Comment on the Applicant's Response to RFI paragraph 69

REQUEST FOR INFORMATION

Request for evidence of the viability constraint associated with reduced installed capacity.

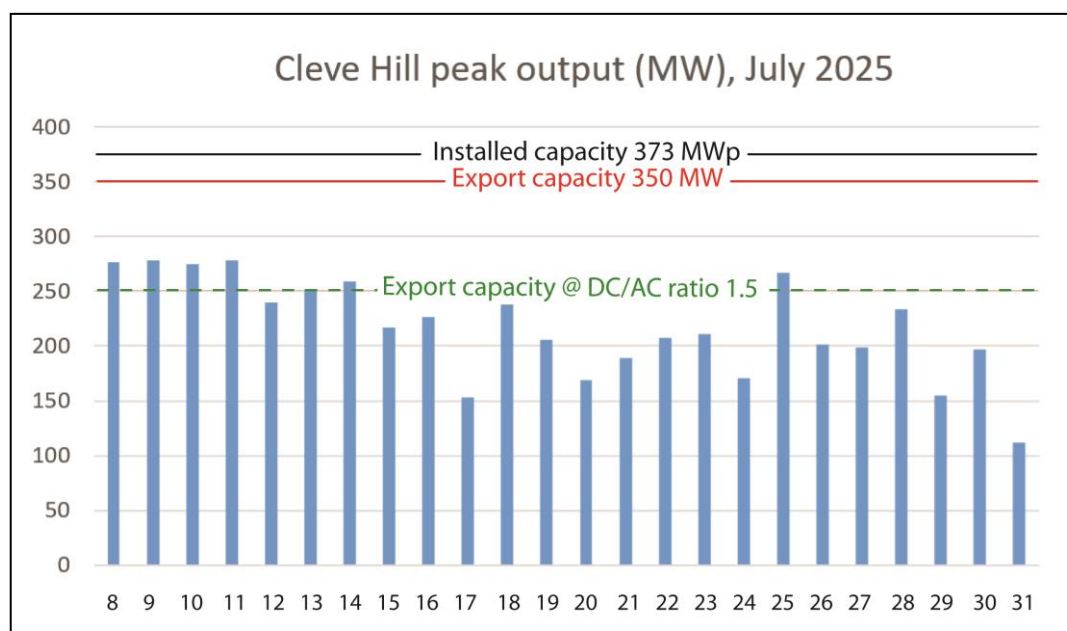
Cleve Hill has a 350 MW connection agreement. It rarely meets 250 MW (see below).

Cleve Hill (373 MWp) had an agreed export capacity of 350 MW. It started export at full power on July 8th 2025. It rarely achieves 250 MW.¹

If its inverters had been capped for a peak export of 250 MW (i.e. DC/AC ratio 1.5), 0.08% of its annual energy production would be sacrificed,² and NGET would have been spared having to install the additional 100 MW of substation capacity.

This real-world example illustrates why EN-3 promotes overplanting.
